#### ROCKFORD BOARD OF EDUCATION INVITATION FOR BID ON SUPPLIES, MATERIALS, EQUIPMENT OR SERVICES FOR SCHOOL DISTRICT NO. 205 ROCKFORD, ILLINOIS

IFB No. 17-25 Rockford Public School District 205 School A, Zone 2

RE: **ADDENDUM NO. 2**

Rockford Public School District 205 School A, Zone 2 Cherry Valley, IL Cannon Project No. 005005.00 Cannon Design 225 N. Michigan Ave, Suite 1100 Chicago, Illinois 60601

1 LEVEL 01 HVAC PIPING PLAN - AREA A

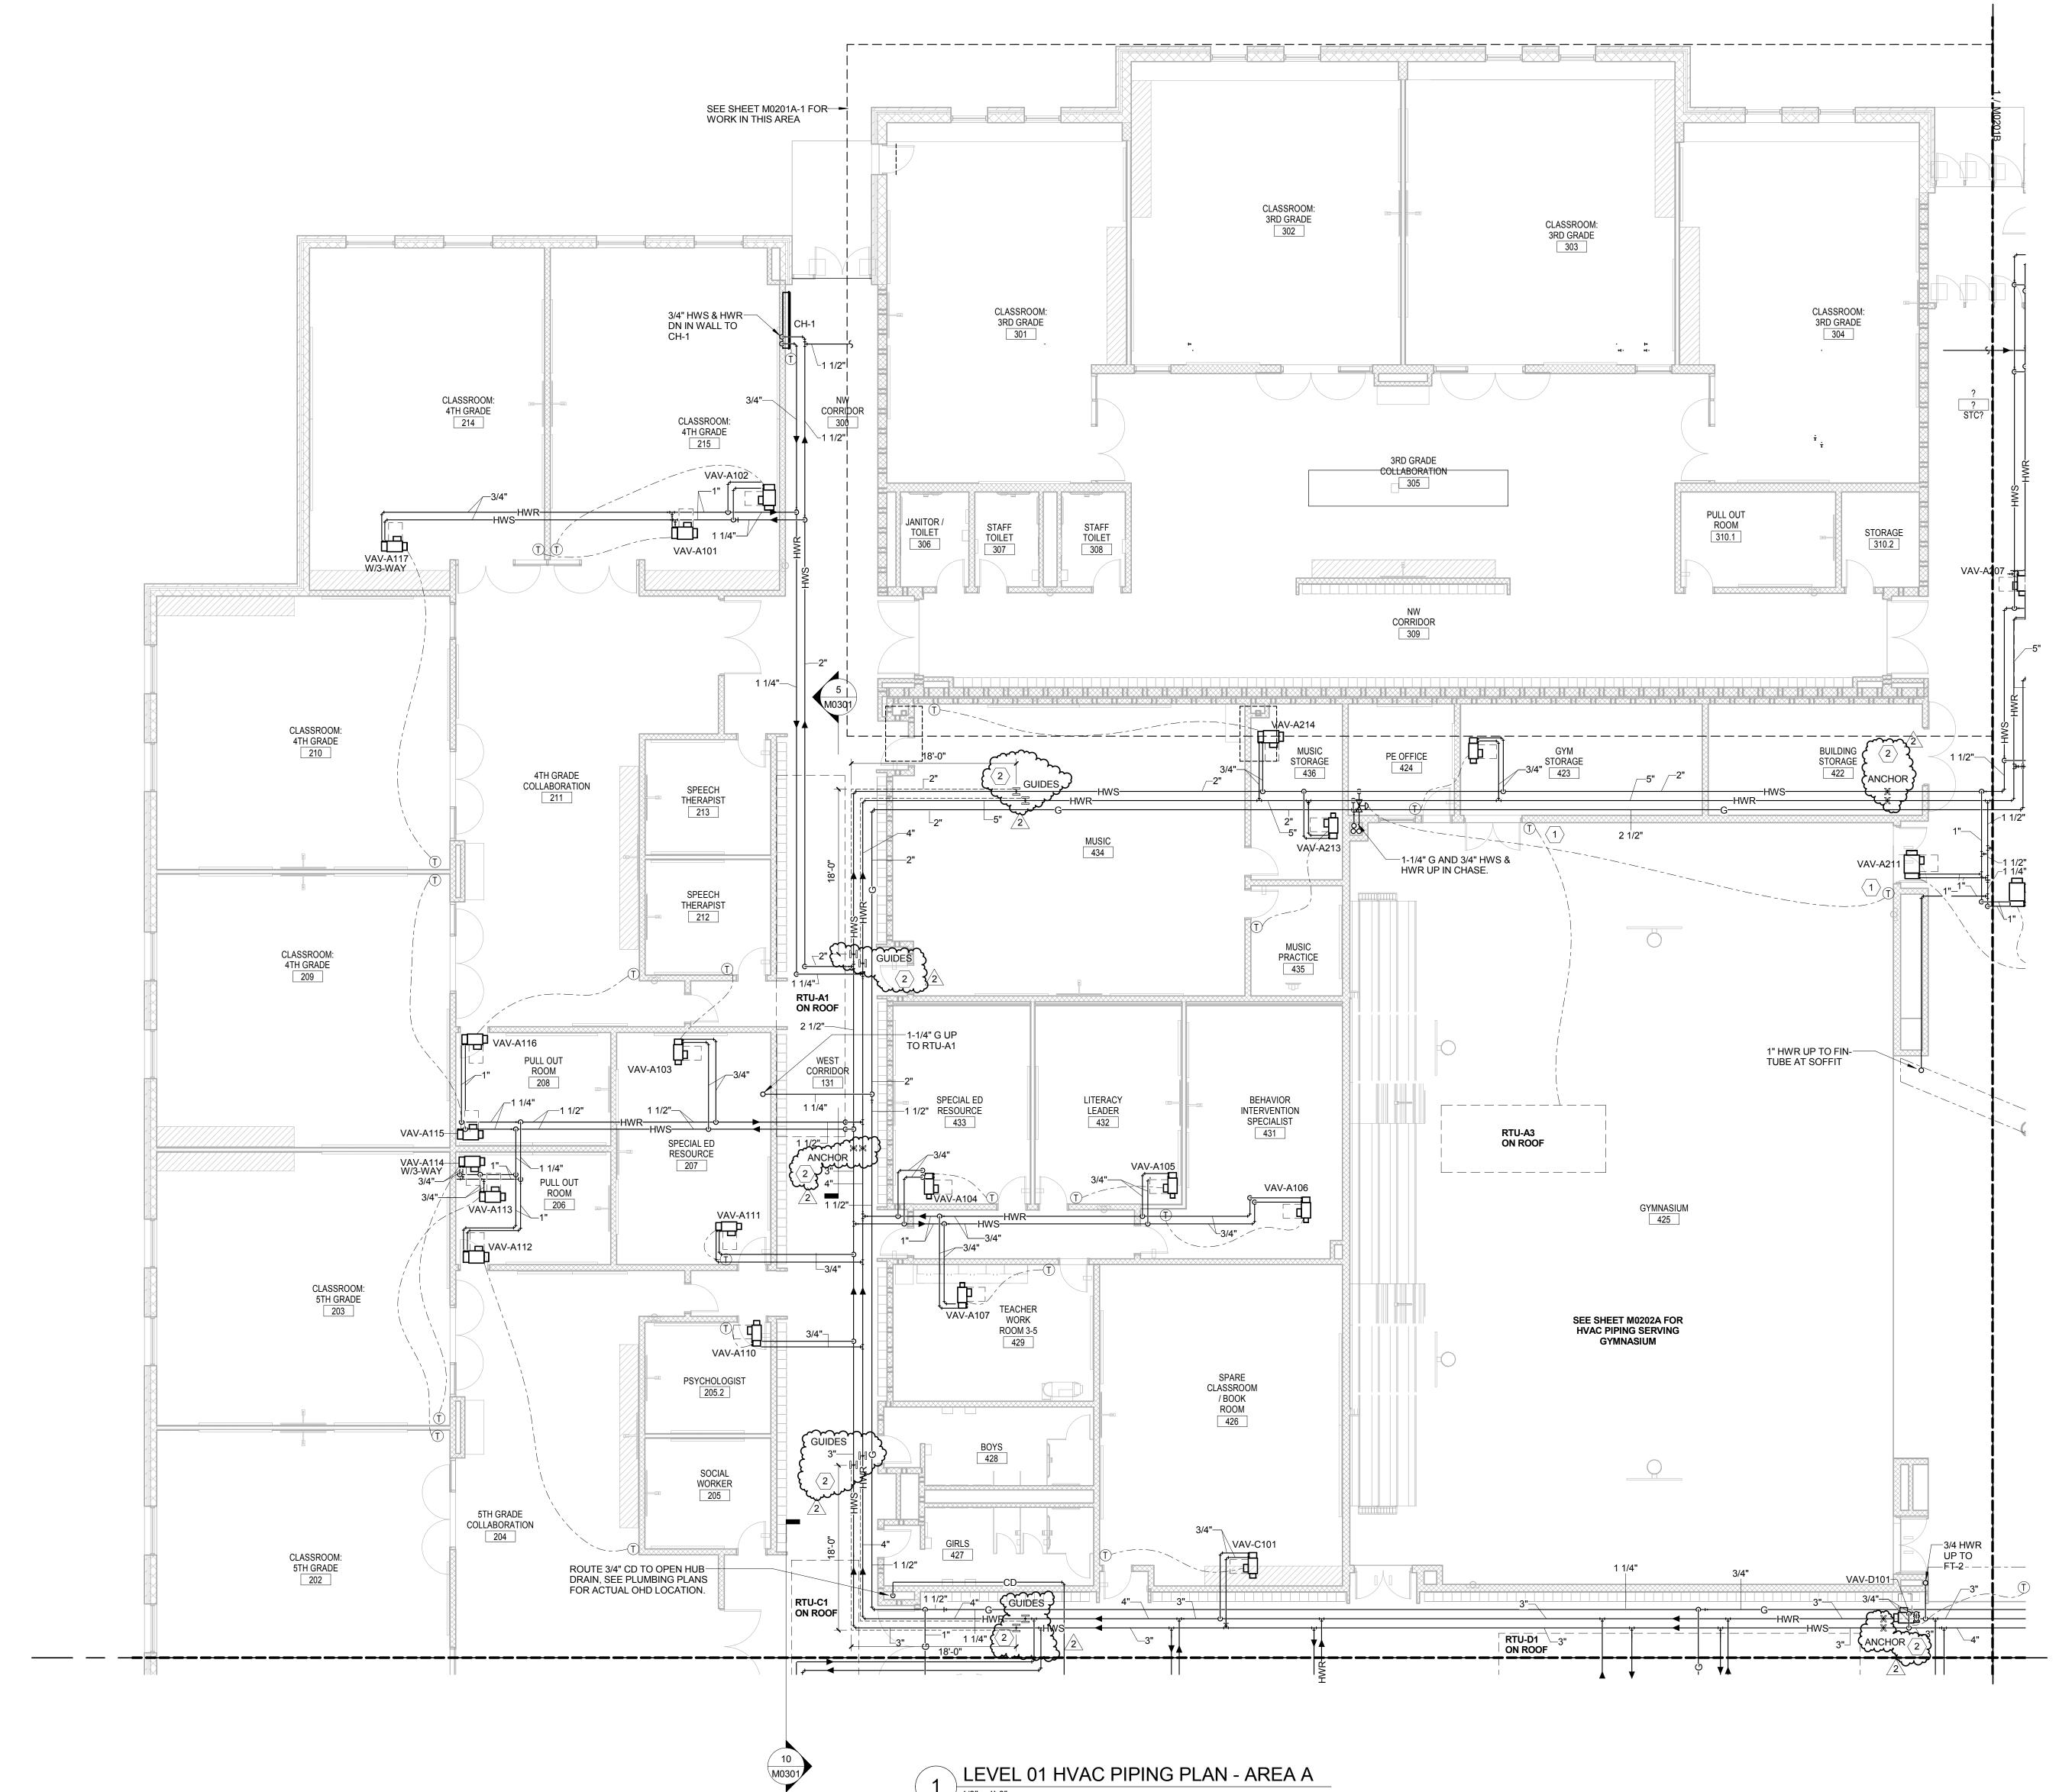
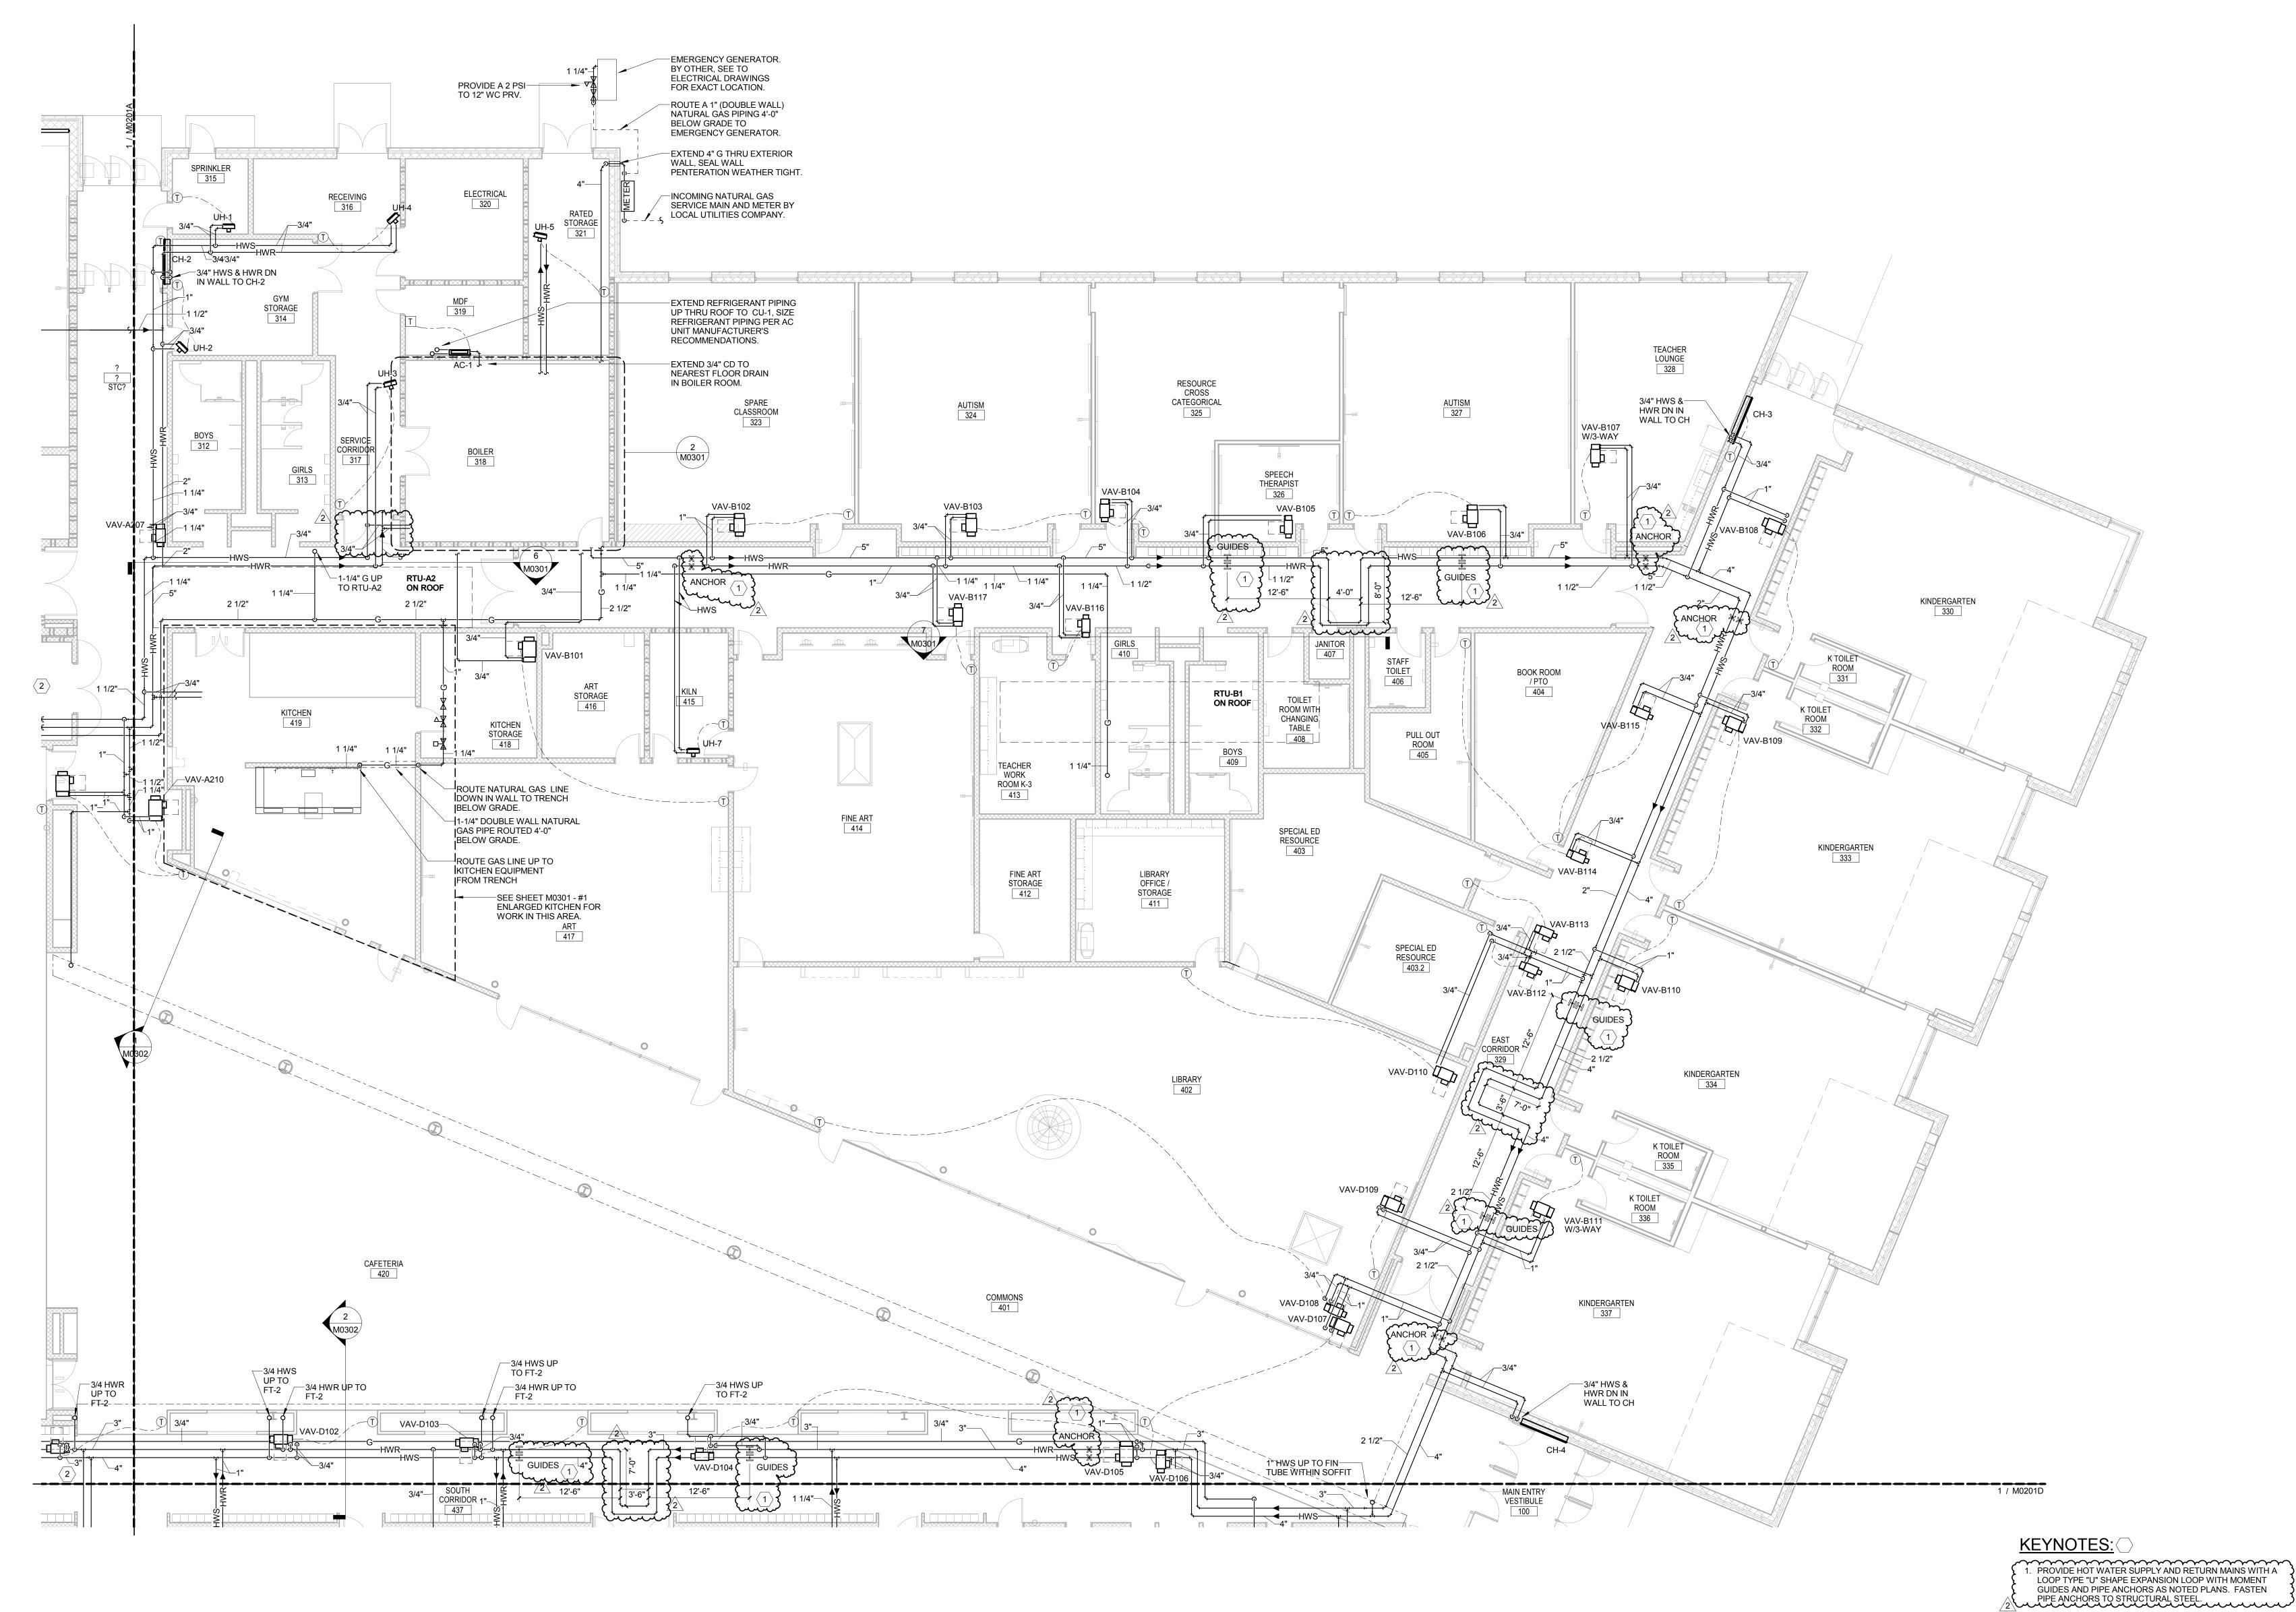
- A. Expansion loop(s) for hot water piping were added.
- B. Added keyed note #2
